**Performance Assessment for the Saltstone Disposal Facility at the  
Savannah River Site: Quality Assurance Report**

**January 2020**

Prepared by: Savannah River Remediation LLC  
Waste Disposal Authority  
Aiken, SC 29808

**Figure 7.1-1. Example of Cross-Sections Used to Estimate Overburden Thicknesses**

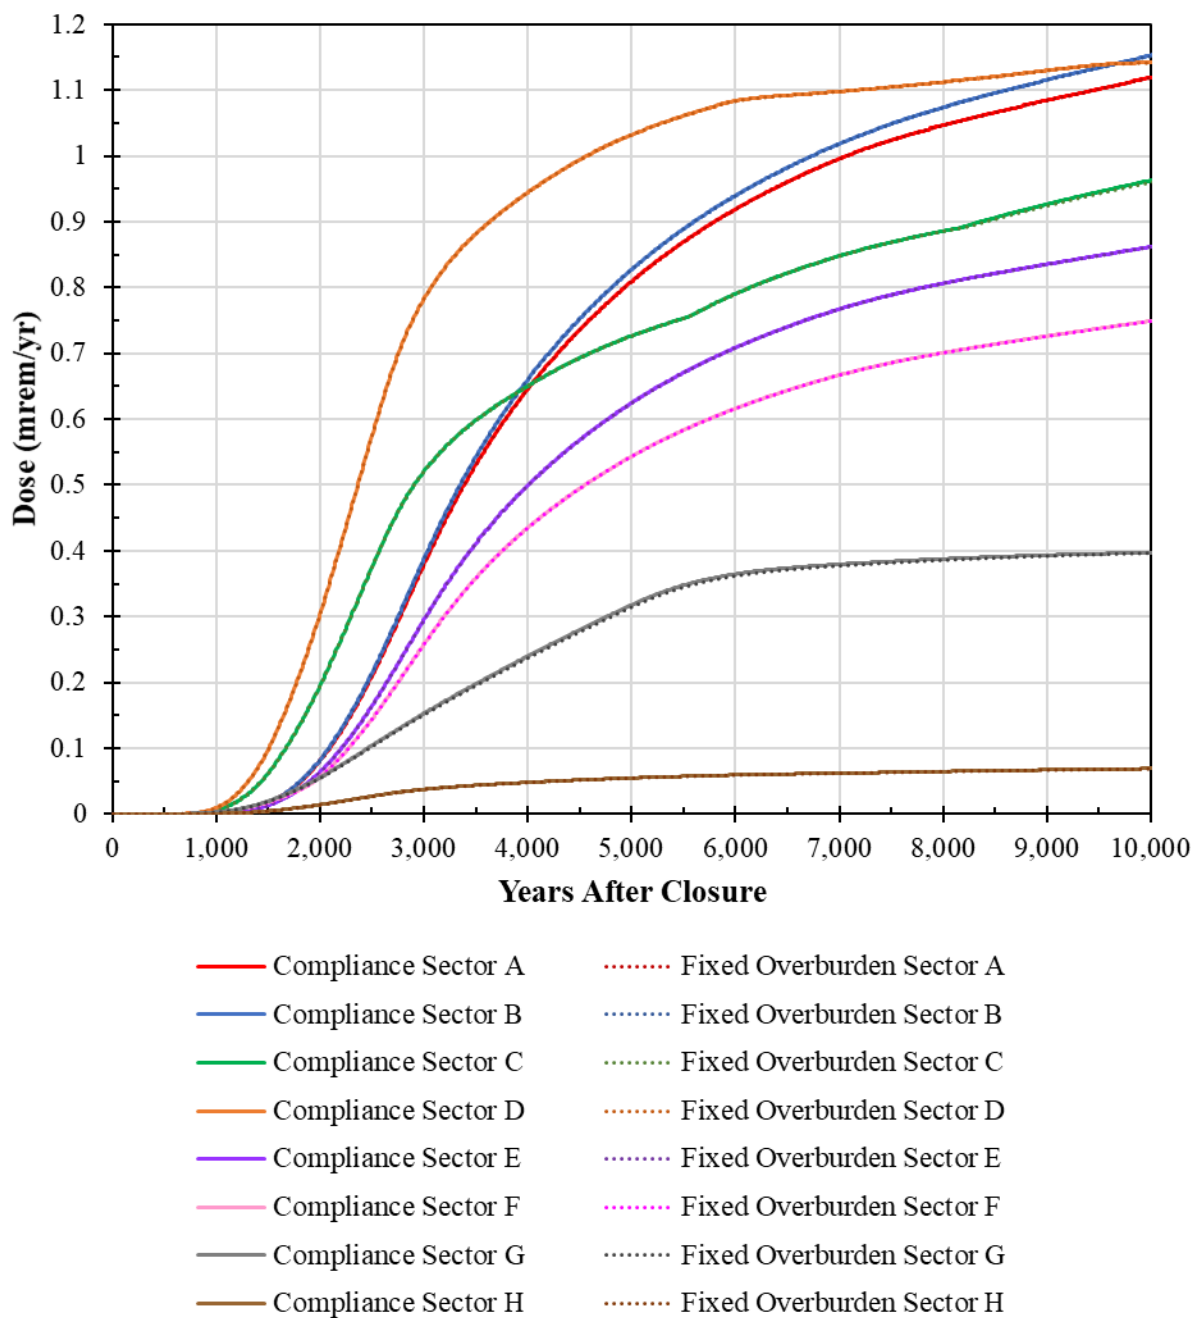
### **7.1.2      *Uncorrected Irregularity #2: Use of Incorrect Closure Cap Backfill Thickness***

The PORFLOW models assume specific values for the thickness of the overburden (i.e., the thickness of the lower backfill layer above each SDU). The values assumed were based on the previous closure cap design:

- SDU 1 = 4 feet of overburden
- SDU 4 = 24 feet of overburden
- All other SDUs = 7 feet of overburden

The new closure cap design applies a 12-inch minimum to the lower backfill layer, and based on the updated design drawings (SRR-CWDA-2018-00087), the thicknesses of this overburden are typically close to this minimum near the SDU edges. Regardless, the closure cap design is still considered preliminary and will be evaluated for final design conditions once those have been established.

closure cap, the “overburden” thickness can be determined by estimating the thickness of the backfill above each SDU as depicted in the SRR-CWDA-2018-00087. For example, based on cross-section B-B (shown here as Figure 7.1-1), the average overburden thickness above SDUs 6, 7, and 8 are estimated to be 18.7 feet, 12.0 feet, and 5.5 feet, respectively.

Based on these estimates, the average overburden heights for each SDU were estimated as presented in Table 7.1-1. This table also indicates the values that were assumed for the models in the SDF PA, and values that were assumed for a standalone model that was developed to evaluate the potential impacts of this uncorrected error. Note that SDU 1 and SDU 6 were not modified because the SDF PA already assumed values that were relatively close to the correct value. SDUs 7, 8, 10, 11, and 12 were also not modified, because all five of these SDUs rely on the same Vadose Zone models, and the average overburden for these SDUs is 7.1 feet which is also close to the value already used in the SDF PA. Therefore, only the overburden over SDU 4, SDU 6, and the 150-foot diameter SDUs were modified. For the 150-foot diameter SDUs, the average overburden thickness for SDUs 2A, 2B, 3A, 3B, 5A, and 5B (17.9 feet) was assumed.

These “fixed” overburden values were applied to the Vadose Zone Flow Model and the Vadose Zone Transport Model to recalculate flow and transport results. The resulting mass fluxes were applied to the Aquifer Transport Model to estimate the ground water concentrations which were then used to estimate modified dose results. Comparing these doses to the Compliance Case results (Figure 7.1-2) demonstrates that the impact of the overburden thicknesses is negligible, even in Sectors F and G where releases from SDU 4 had the potential to show a greater difference.

**Figure 7.2-2: Cl-36 Flux at the Water Table from SDU 1, Comparison of the Effects of Model Boundary Conditions versus Flux from GoldSim Benchmarking**

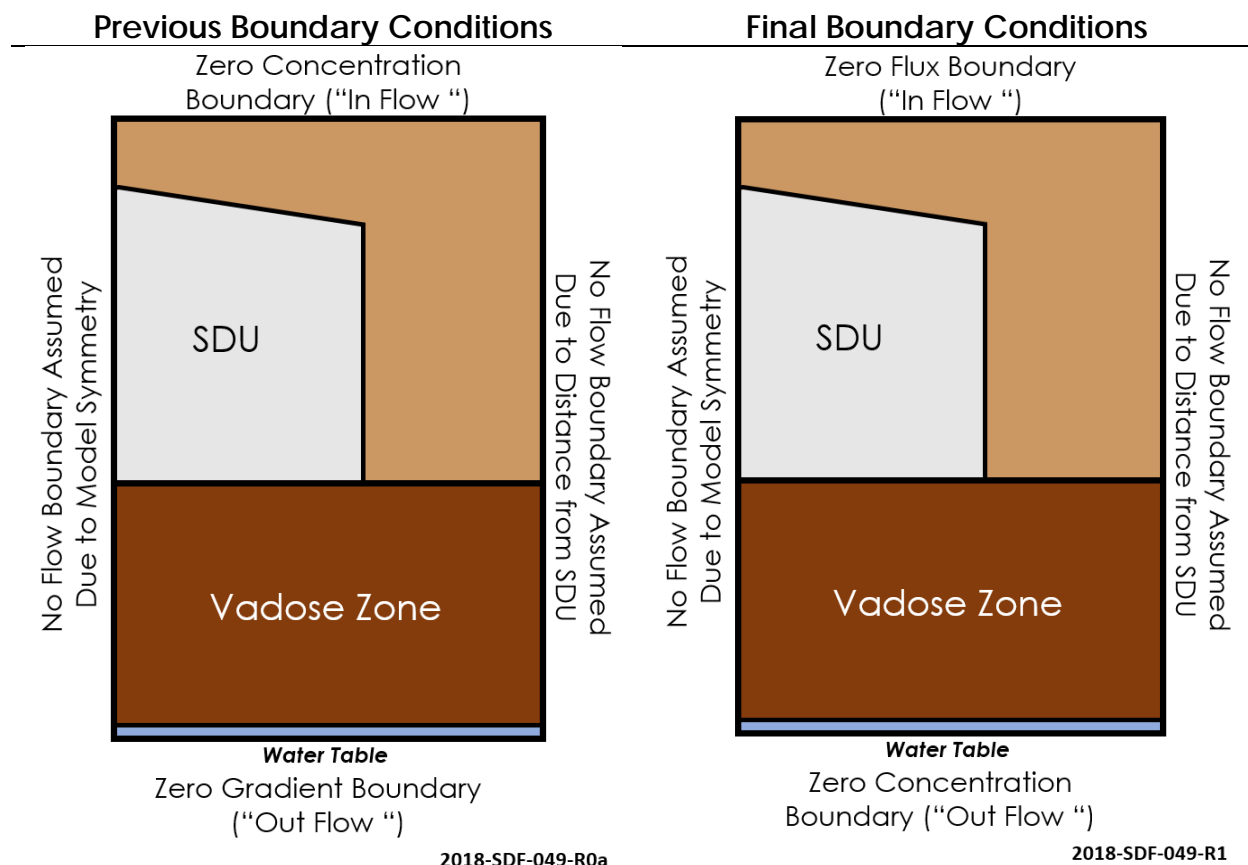
### 7.2.9 *Corrected Irregularity #9: Application of Boundary Conditions for PORFLOW Vadose Zone Modeling*

During the development of the GoldSim Benchmarking analysis, it was determined that fluxes from the SDU-specific Vadose Zone Transport Models (via PORFLOW) showed initial model results with inexplicable behavior. Specifically, at very early times (while flow rates were extremely low) fluxes at the water table were occurring at rates that should have been physically impossible given the low flow rates. This phenomenon was most pronounced in the fluxes from SDU 1 for highly mobile radionuclides (for examples, see Figure 7.2-2 and Figure 7.2-3).

Upon inspection, it was determined that because the advective flow rates are so low at early times the system is effectively dominated by diffusive releases for the first few thousand years. These diffusive releases were reaching the top of the model domain. In reality, it is expected that any mass that diffuses up from the SDU and reaches to the top of the lower backfill would encounter first the foundation layer of the closure cap (which was not modeled), then it would reach the relatively impermeable composite barrier (HDPE and GCL). The composite barrier is expected to prevent mass from further upward diffusion. However, the model mechanics were such that any mass leaving the model domain was assumed to be mass at the water table, regardless of which boundary is being crossed to exit the model domain. Any flux along either the bottom boundary or the top boundary of the model is treated as flux at the water table. As such, the upward diffusing mass was inadvertently being added to the mass that was being transported downward (into the saturated zone for aquifer transport).

This issue was further complicated by the definition of the boundary conditions at the top of the model. Previously, the top of the model was defined as a zero-concentration boundary instead of a no-flux boundary. This definition for the top of the boundary resulted in mass being “pulled” via diffusive processes from the top of the SDU to the top boundary of the model domain. To correct for this phenomenon, the definitions of the boundary conditions were modified (see Figure 7.2-4).

The flux results in Figure 7.2-2 and Figure 7.2-3 demonstrate that this correction to the boundary conditions in the SDU-specific Vadose Zone Transport Models results in fluxes that very closely reflect the fluxes simulated in the GoldSim Benchmarking model. This reproducibility of behavior provides greater confidence that both models are functioning appropriately.
